DATE: 12/7/23

SUBJECT: ADDENDUM NO. 2 TO THE BIDDING DOCUMENTS FOR

CDB-818-010-103  
REPAIR AND REPLACE ROOFS – PHASE 3  
WESTERN ILLINOIS UNIVERSITY  
ILLINOIS BOARD OF HIGHER EDUCATION  
MACOMB, MCDONOUGH COUNTY, ILLINOIS

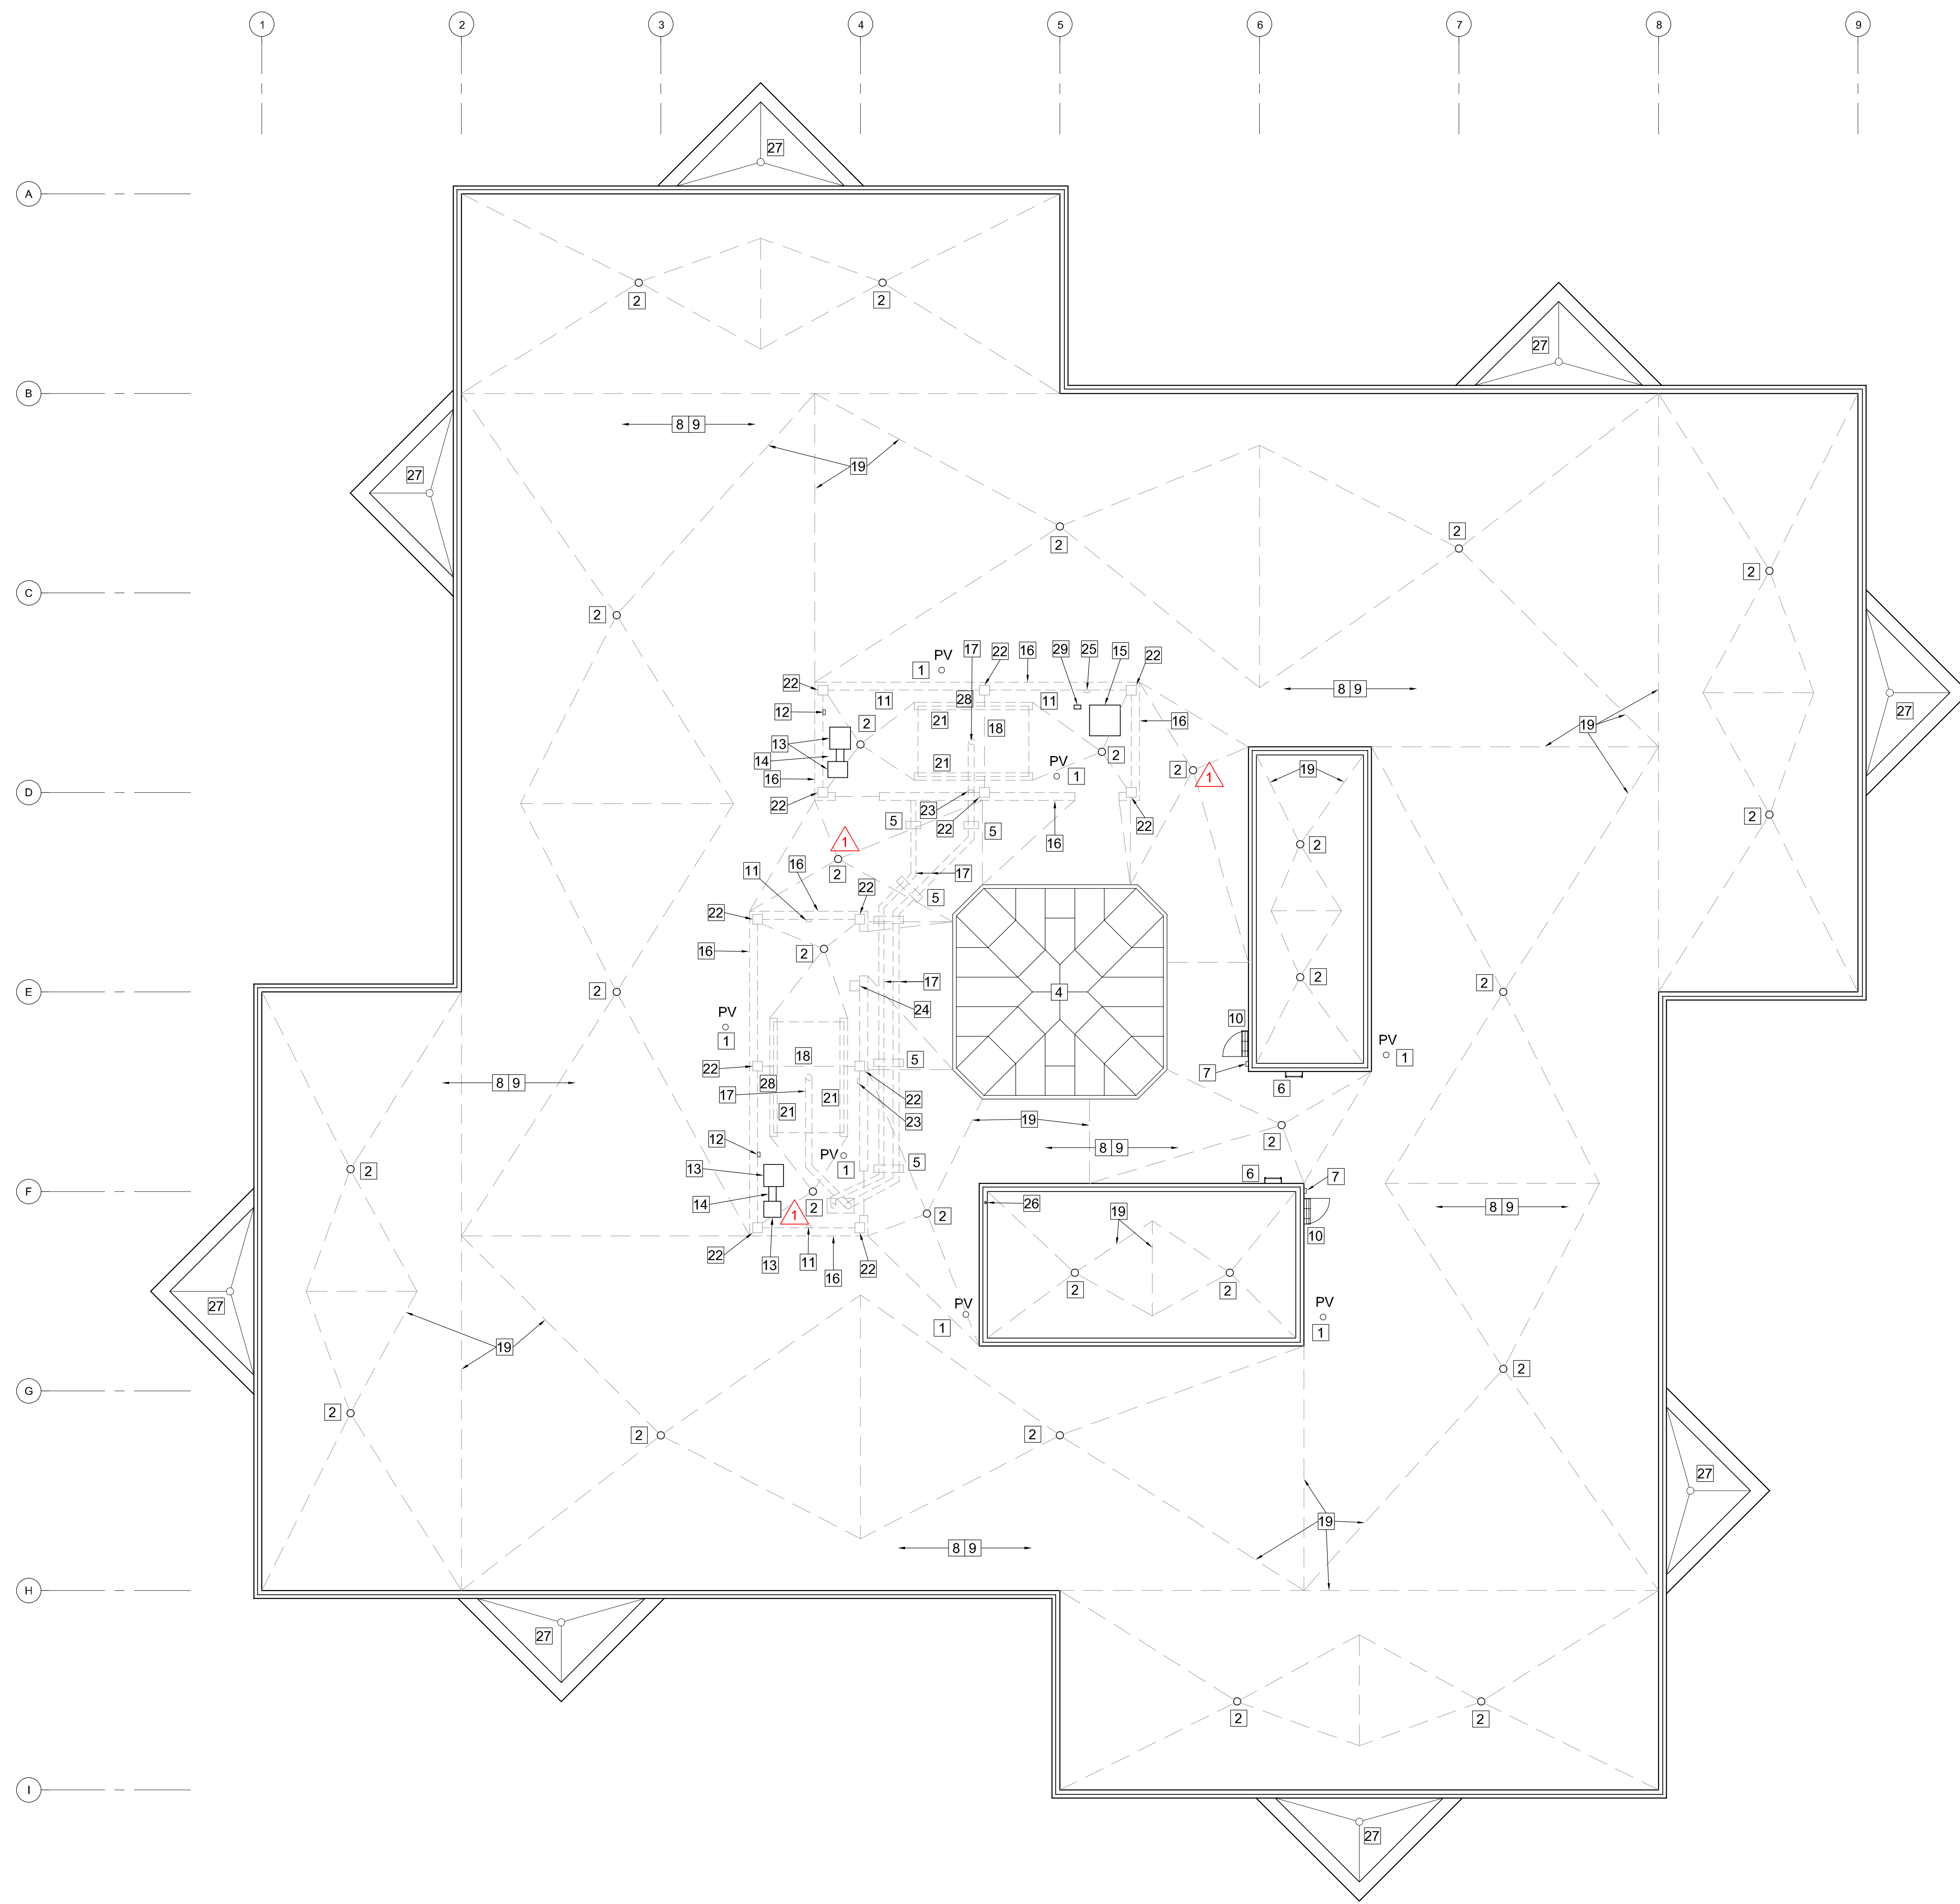
1. SHEET G101: Revise General Note #15 to read, “The Using Agency requests that the Contractor not perform any work at Mowbray Hall and the Beu Health Center during these dates due to construction noise”.

15. THE USING AGENCY REQUESTS THAT THE CONTRACTOR NOT PERFORM ANY WORK AT MOWBRAY HALL AND THE BEU HEALTH CENTER DURING THESE DATES DUE TO CONSTRUCTION NOISE:  
DECEMBER 11-15, 2023  
MAY 6-10, 2024

ROOF DEMOLITION PLAN - MALPASS LIBRARY		PROJECT NO. 818-010-103
REPAIR AND REPLACE ROOFS - PHASE III		DATE 11/6/2023
ILLINOIS BOARD OF HIGHER EDUCATION		SHEET NO. <b>D101</b>
WESTERN ILLINOIS UNIVERSITY		OF (13) SHEETS
MACOMB, McDONOUGH COUNTY

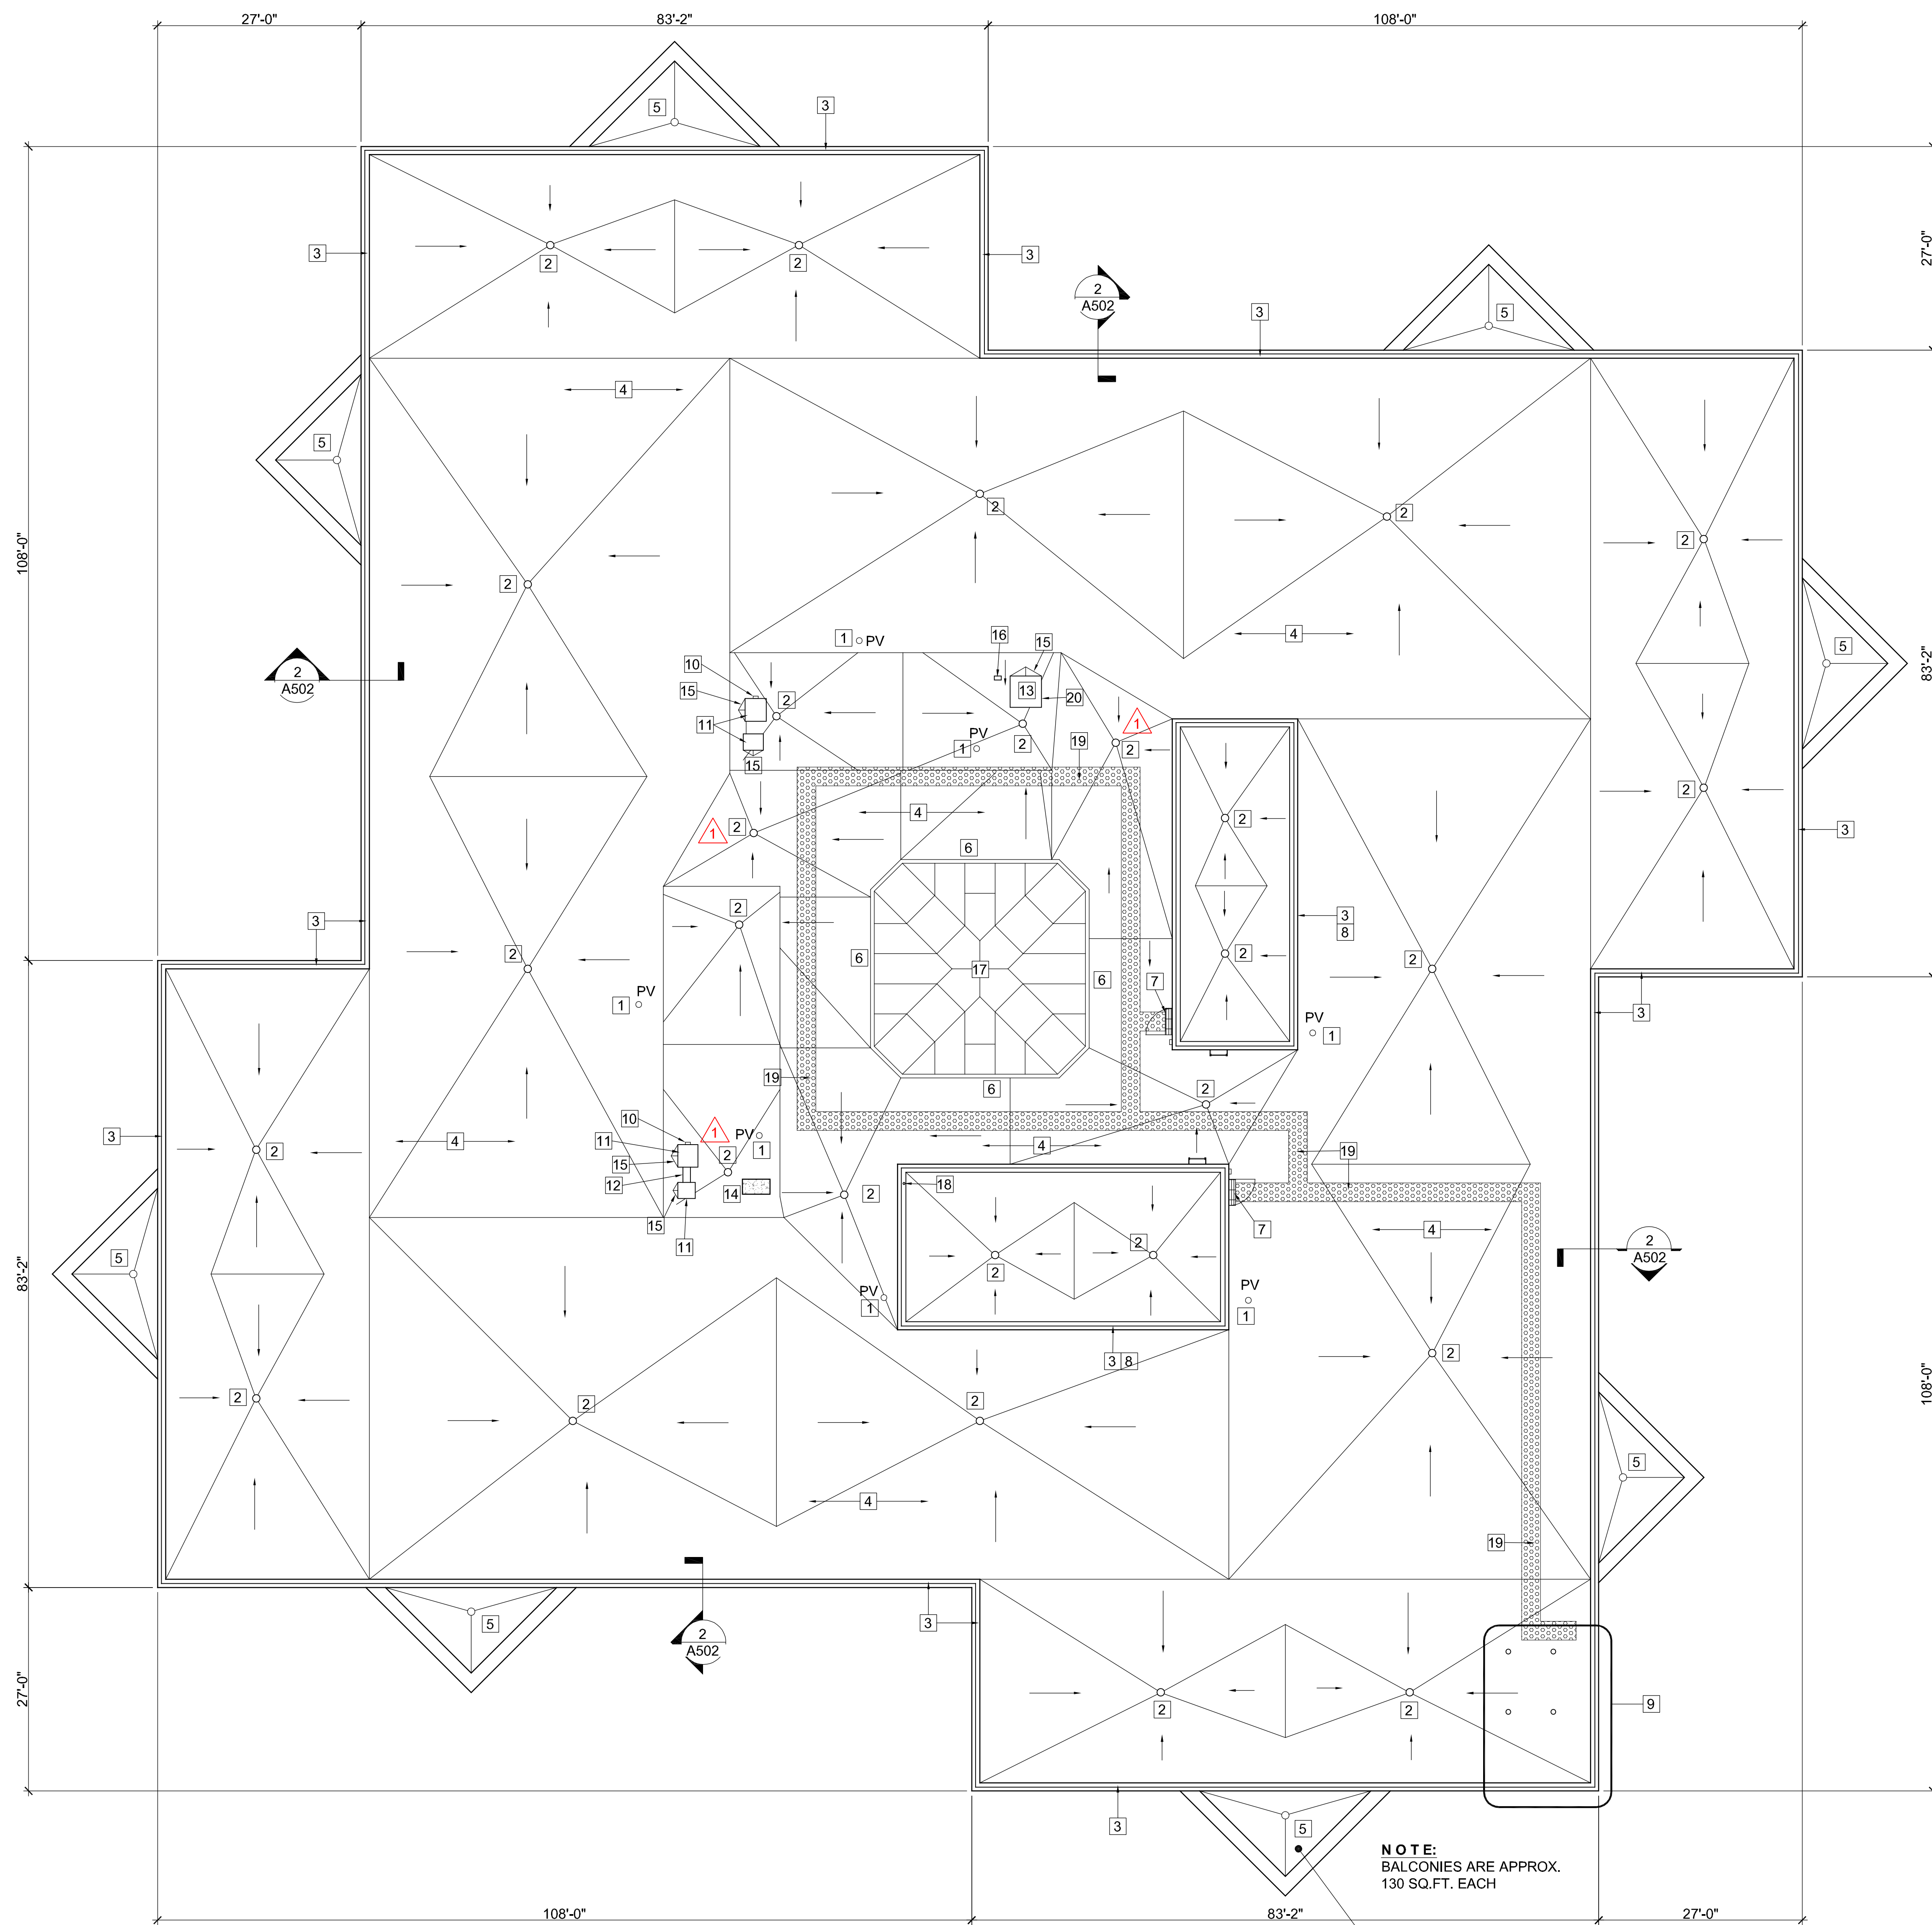
2. SHEET D101: Revise Keyed Note #9 to read, “Existing membrane and roof insulation to be removed down to existing lightweight fill”.
3. SHEET D101: Revise Keyed Note #19 to read, “Dashed line indicates existing slope line of lightweight fill to remain, remove and replace damaged fill as required”.

4. SHEET D101: Delete Keyed Note #20 – existing roof drain to remain in (3) noted locations.
5. SHEET A101: Revisions are as follows:
  - a. Insulation slope lines have been removed, existing lines of lightweight fill shown.

8. EXISTING STONE BALLAST TO BE REMOVED AND STOCKPILED FOR USING AGENCY. SEE DRAWING G101 FOR LOCATION
  9. EXISTING MEMBRANE AND ROOF INSULATION TO BE REMOVED DOWN TO EXISTING LIGHTWEIGHT FILL. EXISTING INSULATION LAYER CONTAINS ASBESTOS AND SHALL BE PROPERLY ABATED. SEE SPEC. 02 08 00 AND 02 26 25

19. DASHED LINE INDICATES EXISTING SLOPE LINE OF LIGHTWEIGHT FILL TO REMAIN. REMOVE AND REPLACE DAMAGED FILL AS REQUIRED (MIN. 2" THICK AT ROOF DRAINS AND MAX. 8 1/2" THICK AT ROOF EDGES AND RIDGES)

20. NOT USED
  21. SAWCUT AND REMOVE EXISTING CONCRETE SUPPORT CURB AS LOW AS POSSIBLE TO EXISTING CONCRETE ROOF DECK
  22. EXISTING CONCRETE PENTHOUSE FRAME TO BE REMOVED - SAWCUT AS LOW AS POSSIBLE TO EXISTING CONCRETE ROOF DECK

ROOF PLAN - MALPASS LIBRARY		PROJECT NO. 818-010-103
REPAIR AND REPLACE ROOFS - PHASE III ILLINOIS BOARD OF HIGHER EDUCATION WESTERN ILLINOIS UNIVERSITY MACOMB, McDONOUGH COUNTY		DATE 11/6/2023
		SHEET NO. <b>A101</b>
		OF (13) SHEETS

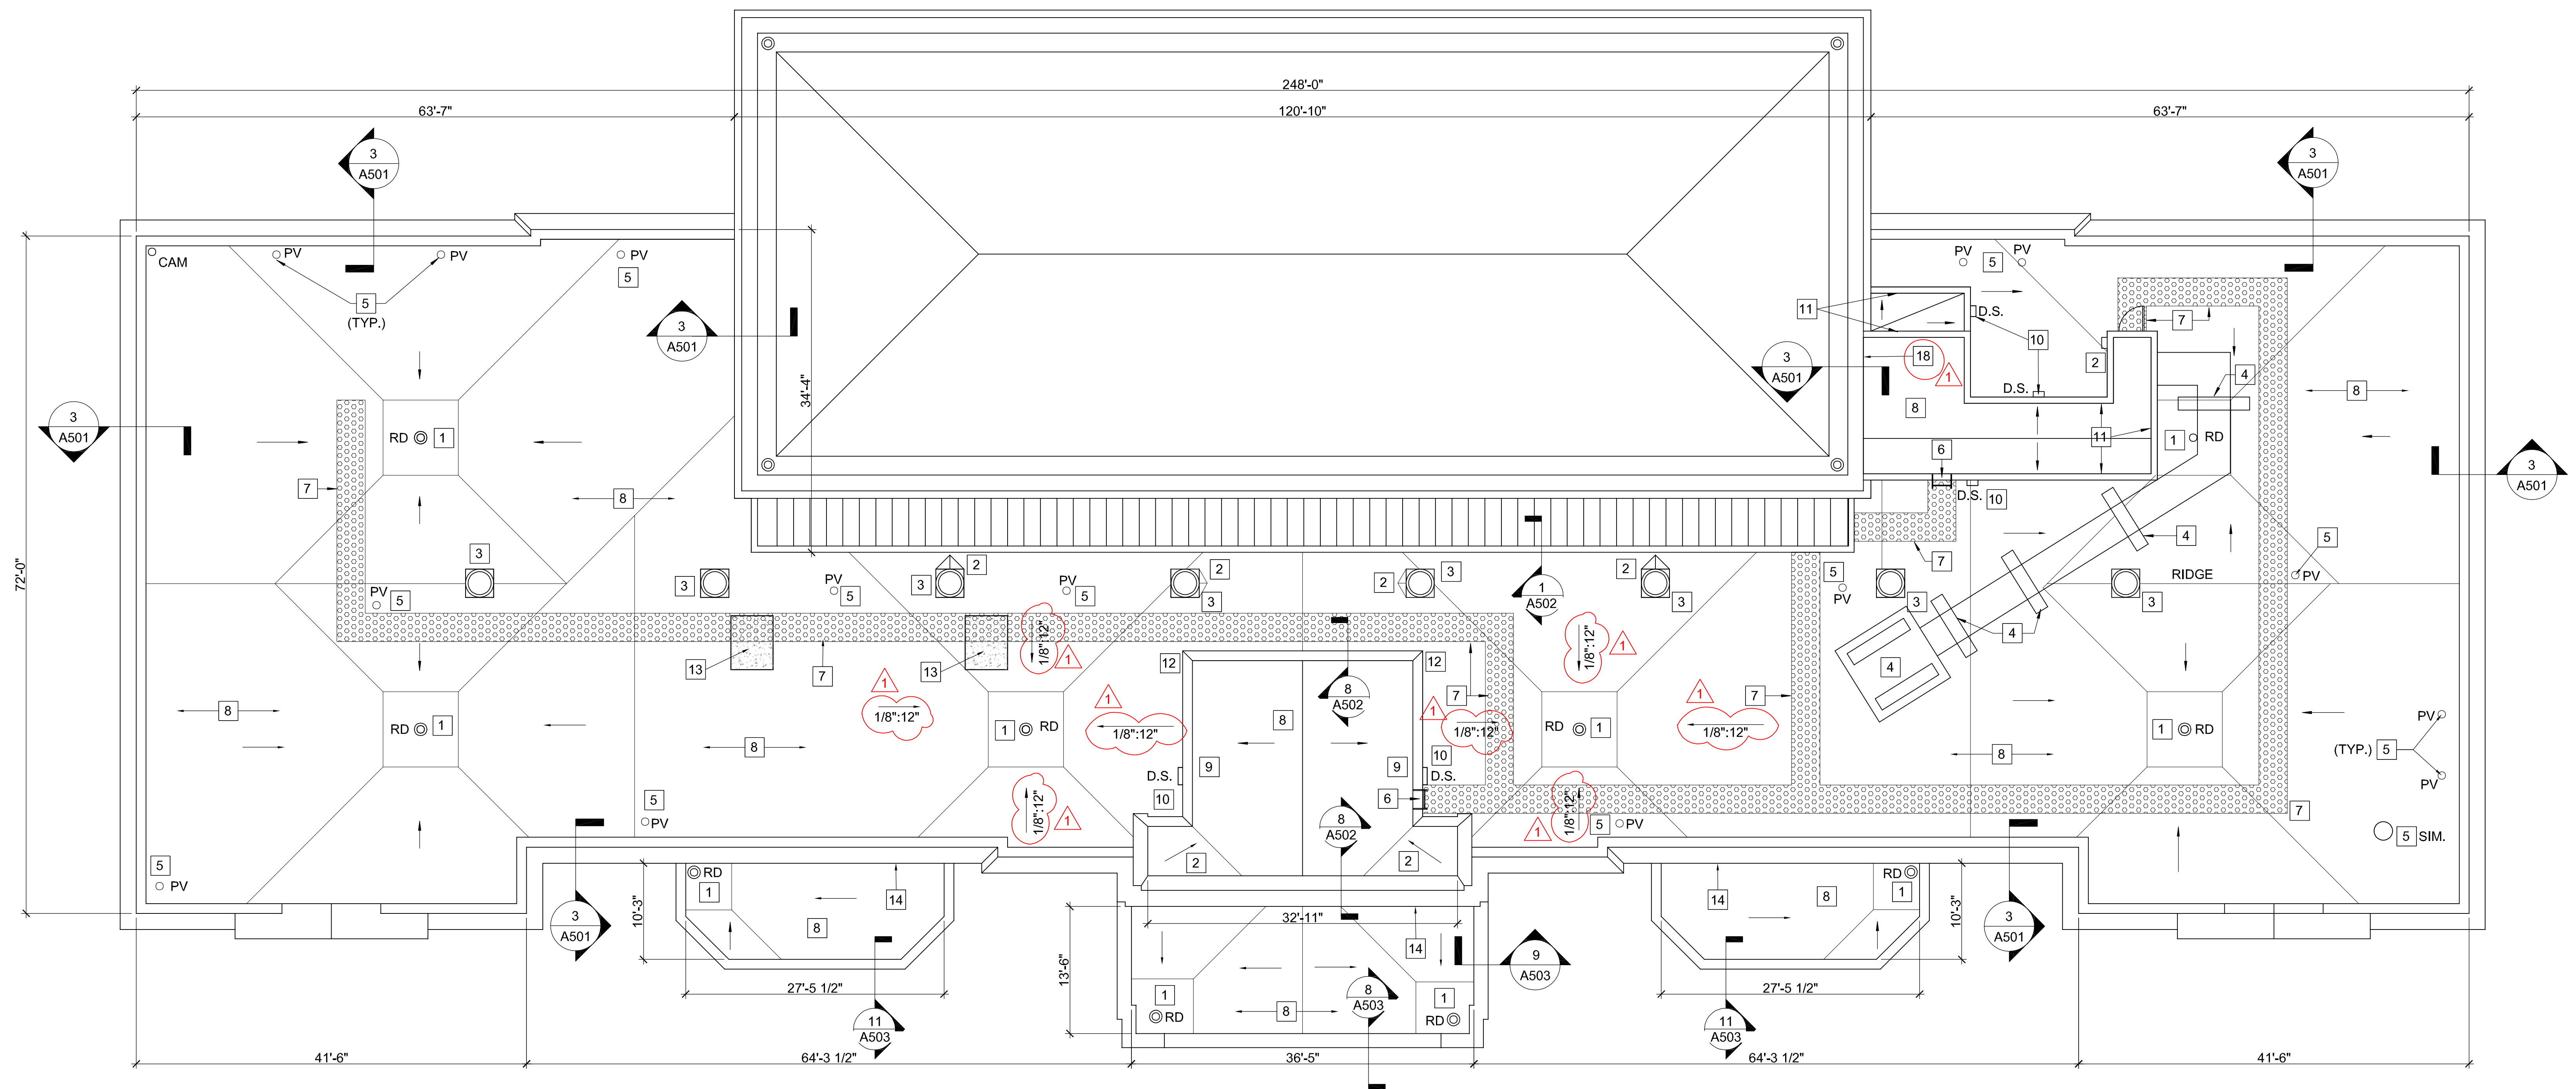
- b. (3) existing roof drains previously called for removal now shown.
  - c. Remove the sloped insulation reference from Construction Note #4 – new insulation will set atop existing sloped lightweight fill. Contractor to verify the proper adhesive required for securing new insulation boards to existing fill.

3. NEW COPING ATOP EXISTING CONCRETE PARAPET, SEE DETAIL 2/A502
4. NEW INSULATION, RECOVERY BOARD, AND EPDM MEMBRANE ATOP EXISTING SLOPED LIGHTWEIGHT FILL. SEE DETAIL 1/A501 (TYPICAL)
